780 BLANSHARD - REHABILITATION + ADDITION

HAV00034 CONCURRENT WITH REZ00825

Bubbled areas indicate revisions compared to the previously submitted plans

DATE	REV	ISSUE DESCRIPTION
2022-02-24	1	REZONING PRE-APPLICATION
2022-06-01	2	OPEN HOUSE PROGRESS SET
2022-06-21	3	REZONING APPLICATION
2023-03-23	4	HAP & REZONING RESUBMISSION

DEMOLITION/RETENTION ELEVATIONS

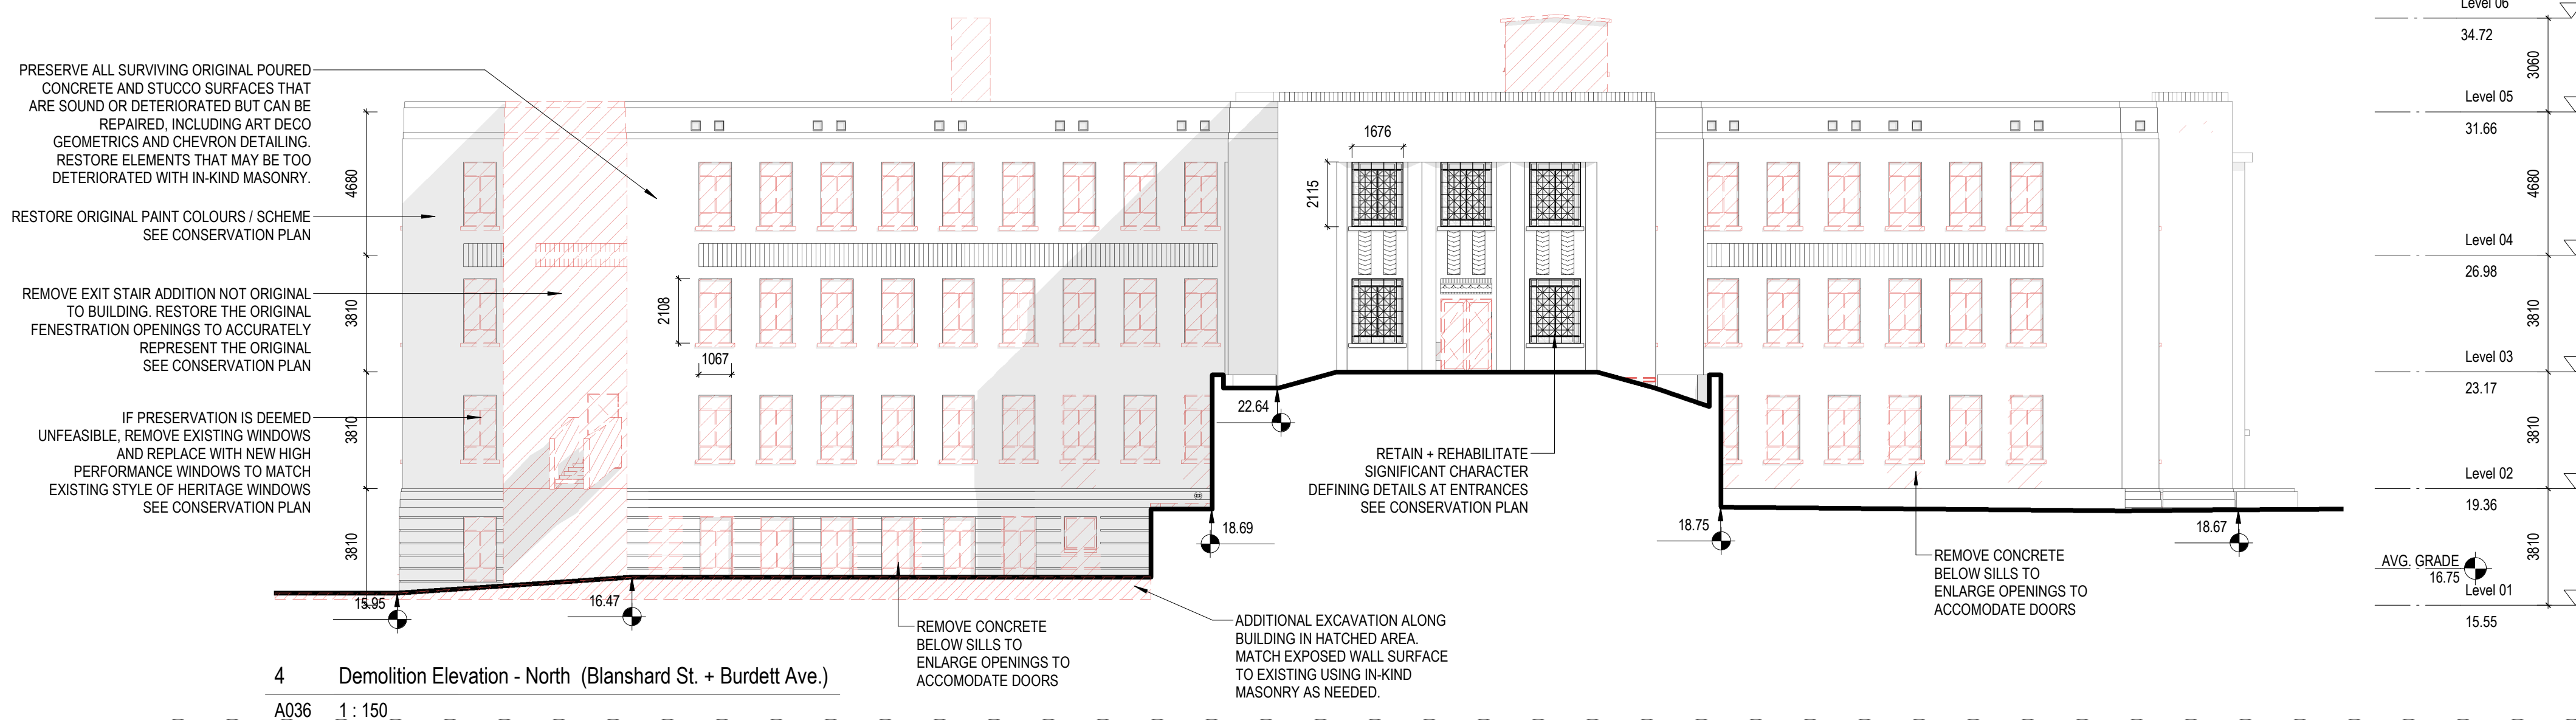
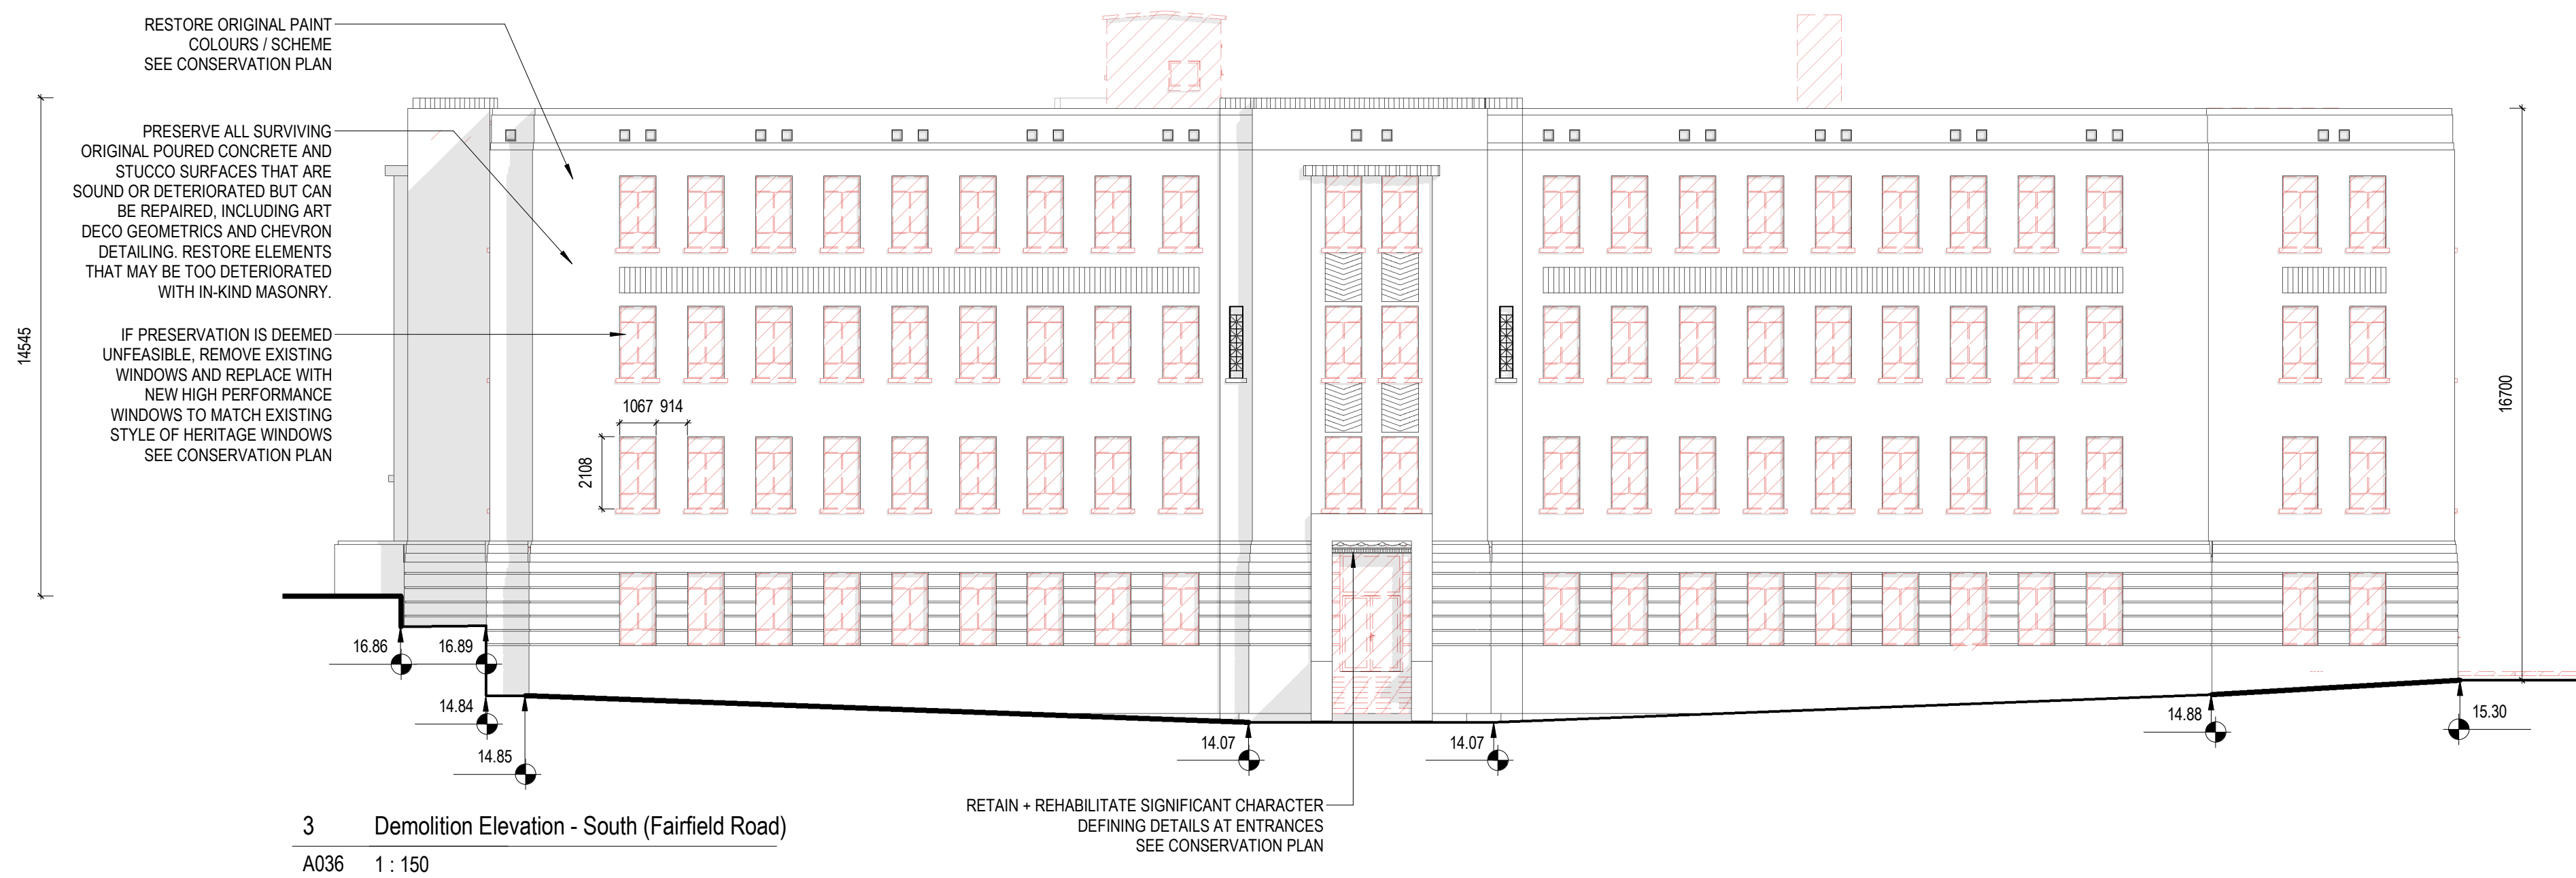
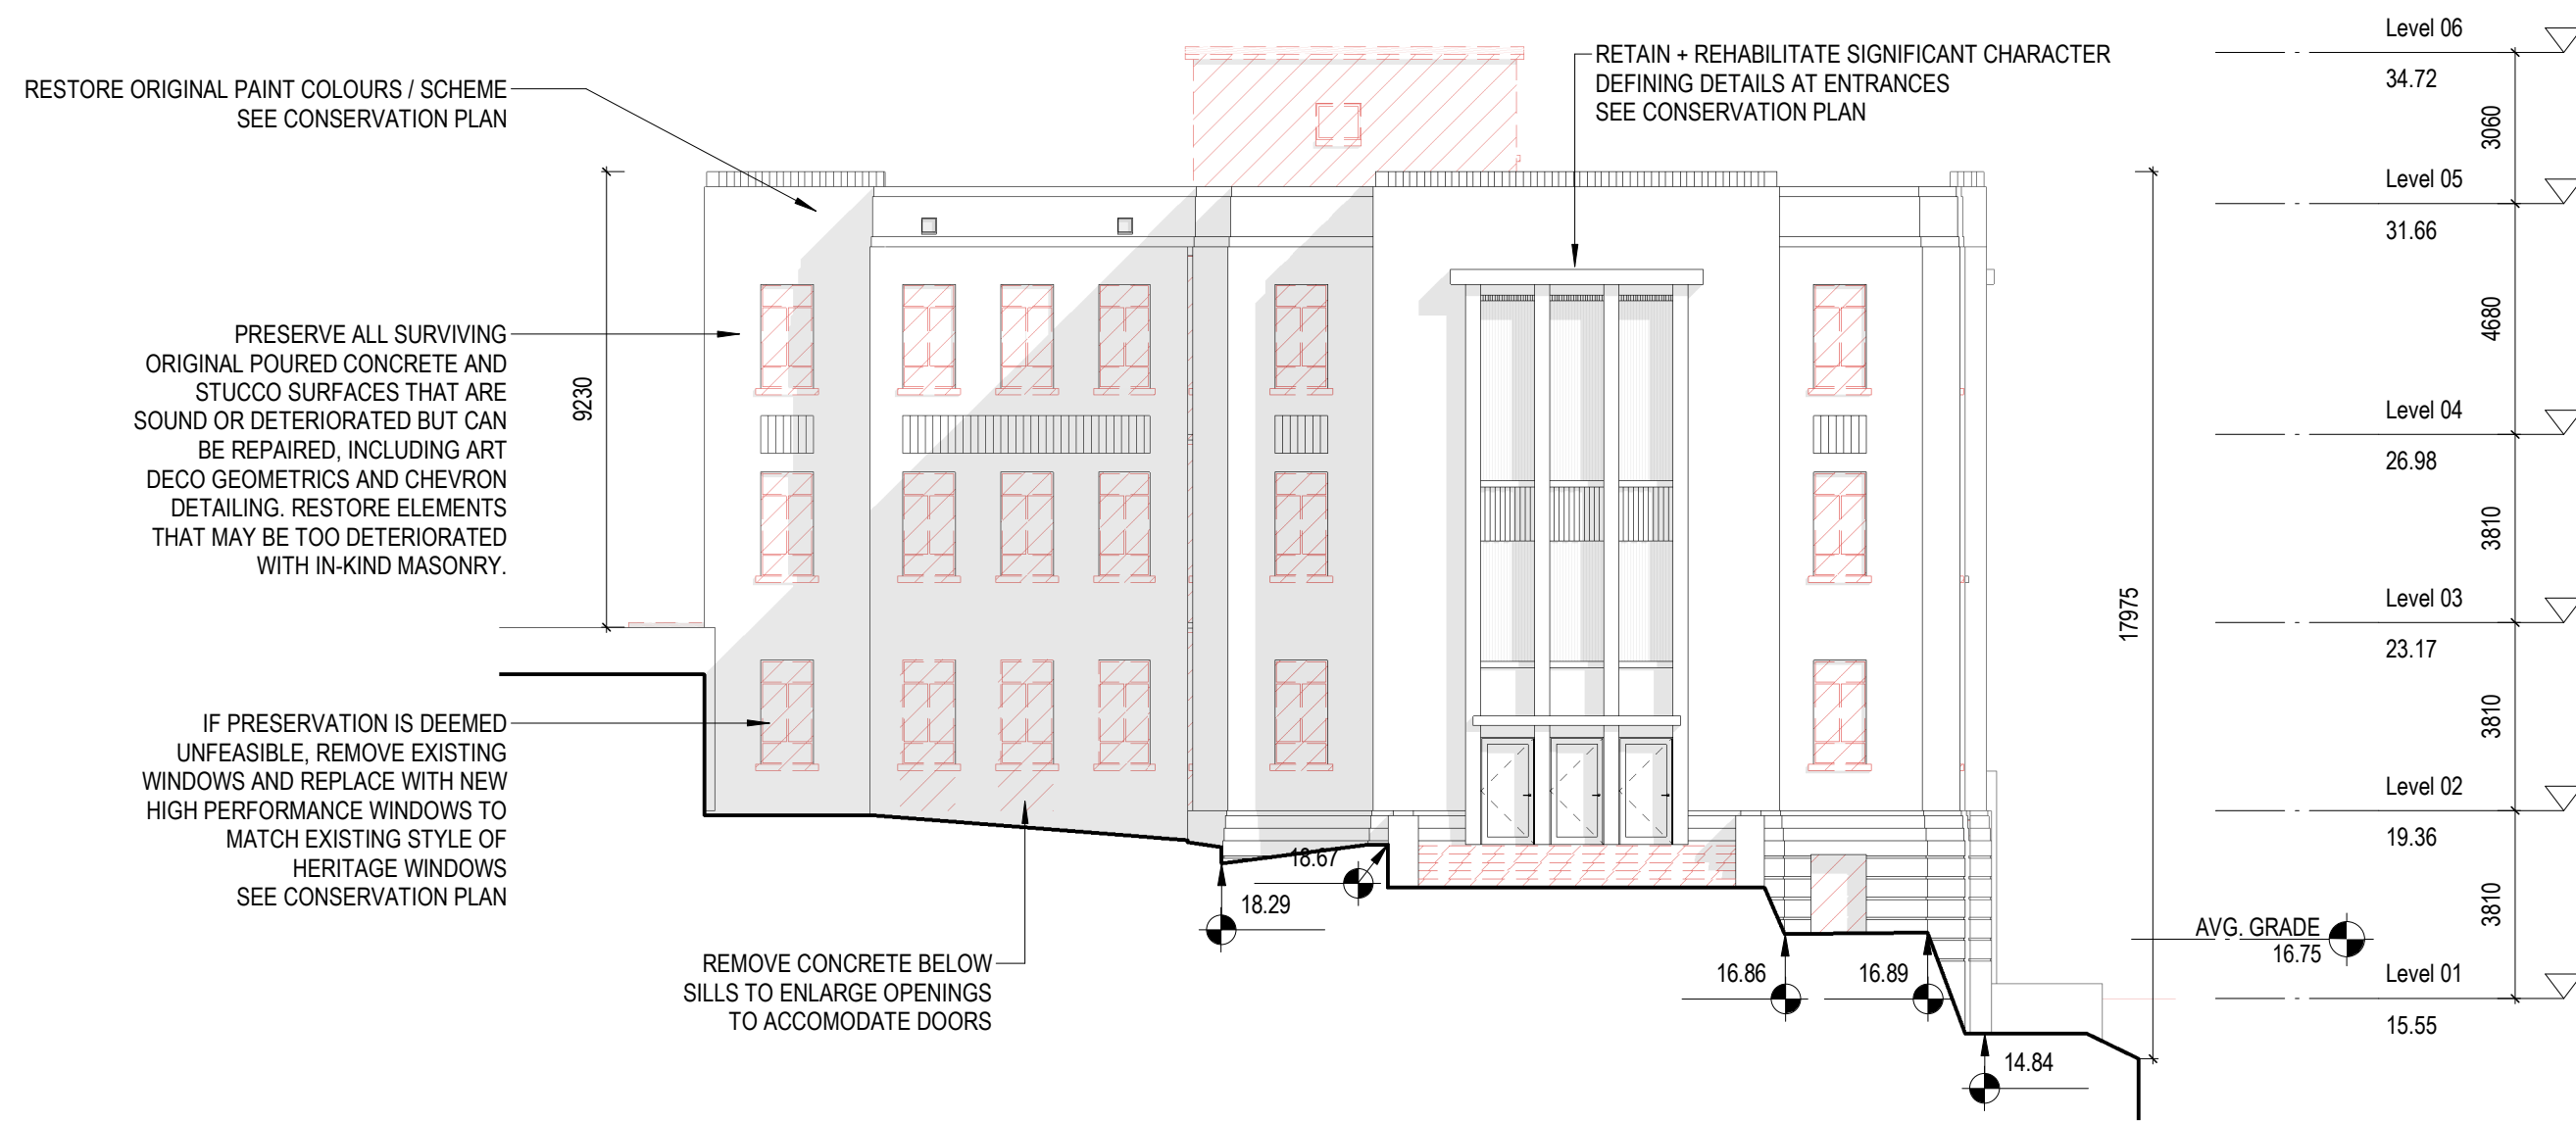
24 Extent of concrete demolition modified to reflect planning updates from interior design development and as a result of missing changes from ARS Comment #22.
